INDIANA DEPARTMENT OF TRANSPORTATION

Design Memorandum No. 21-02

SUBJECT: Mechanically Stabilized Earth (MSE) Walls

REVISES: *Indiana Design Manual* Sections 14-2.01(04), 14-2.01(12), 14-2.02(03), 14-2.04(03), 14-2.04(09), 14-2.05(03), 14-2.05(04), 410-2.03(01), 410-2.03(03), 410-5.01(05), 410-5.01(06), 410-5.01(07), 410-5.02(01), 410-5.03, 410-6.05(01), 410-6.07(01), 410-6.07(03), 410-7.01(01), 410-7.01(02), 410-7.02(03), 410-7.04(01), 410-7.05(01), Figs. 410-5(0)A thru C, MSE Wall Design Review Checklist (new)

Figure 410-5(0)A

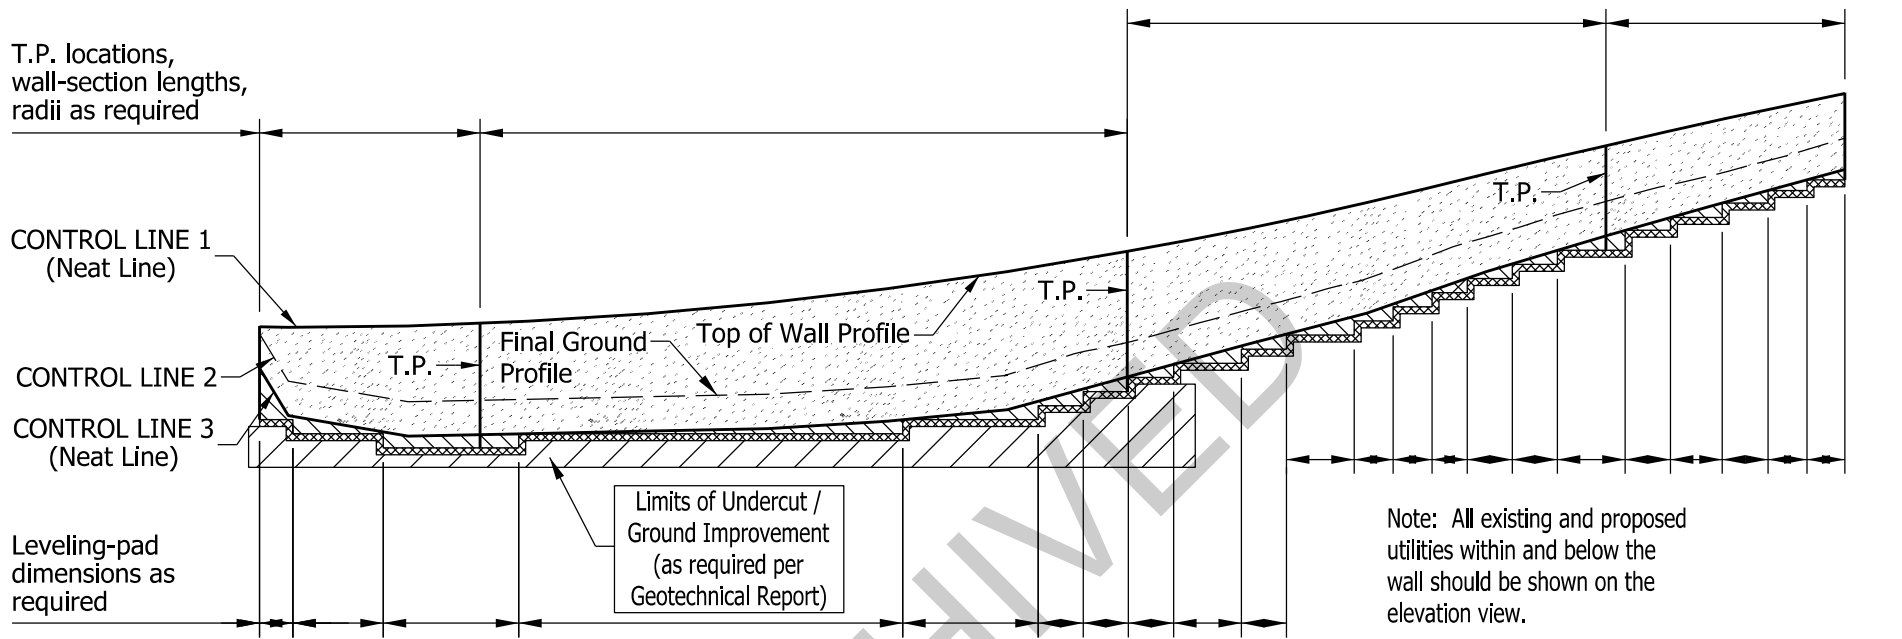
See Figure [410-5\(0\)A](#).

MSE RETAINING WALL SECTION SHOWING EXTERNAL-STABILITY VALUES AND BACKFILL TYPES AND LIMITS

Figure 410-5(0)B

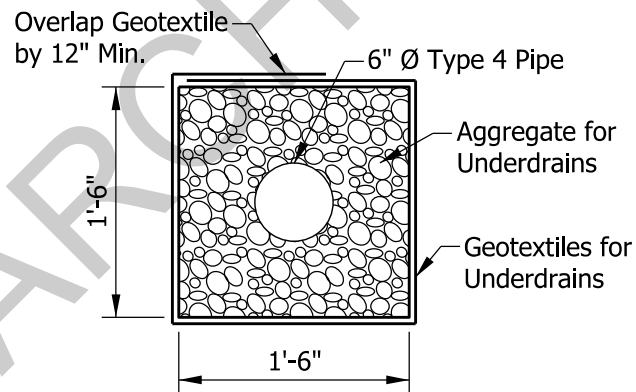
Wall Envelope. The wall envelope should be determined from the plans' elevation view with three control lines. Control Line 1 defines the elevation of the top of coping, or wall, if no coping is used. Control Line 1 should be shown on the elevation view with stations and elevations in conjunction with cross-section locations. It should be located on the back face of the MSE wall or coping. Control Line 2 defines the elevation of the **final** ground line in front of the wall. Control Line 3 defines the elevation of the top of the leveling pad. It is obtained by offsetting a minimum distance of **3 ft** below the proposed ground line in front of the wall to the top of the leveling pad. All control lines should be shown and identified as such on the plans. Control Lines 1 and 3 should also be labeled as neat lines.

The minimum area required for the wall to be constructed should be defined by means of an envelope. The limits of the envelope are the beginning- and end-of-wall stations and the locations of Control Lines 1 and 3. From this information, a wall-elevation view along the front face of the wall showing leveling-pad and step locations, elevations, and dimensions should be prepared and shown on the plans as conceptual information for the contractor. The minimum area within the envelope described above should be the pay quantity for the wall. Figure [410-5\(0\)B](#) shows the difference between the minimum area required and an estimated amount of additional surface area required to construct the wall based on the wall-panel sizes and leveling-pad step increments described below. The area below Control Line 3 is conceptual information for the contractor and should not be included in the panels' pay quantity because it can vary depending on the wall system the contractor chooses. Pay quantities for each wall should be shown on the plans.

TYPICAL MSE WALL ELEVATION VIEW WITH WALL ENVELOPE

Figure 410-5(0)C

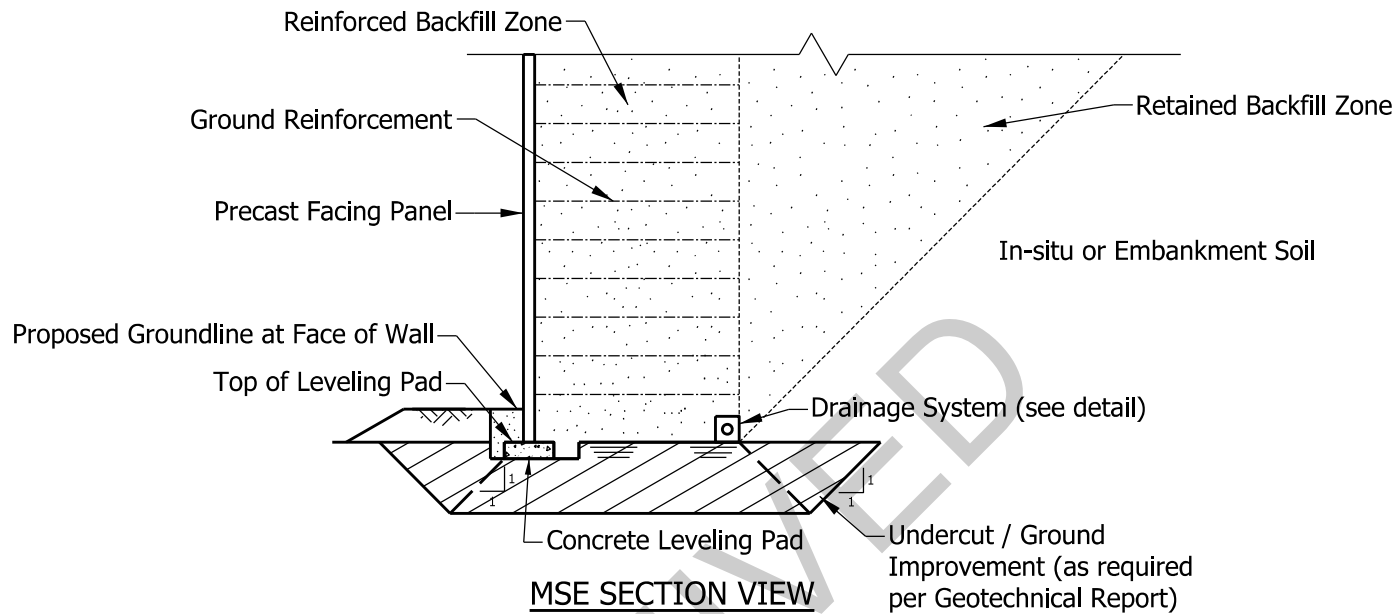
Drainage. Details for drainage of the surface-water infiltration and reinforced-soil backfill should be included for all MSE walls. Figure [410-5\(0\)C](#) shows the standard drainage details. It is the

MSE WALL DRAINAGE DETAIL
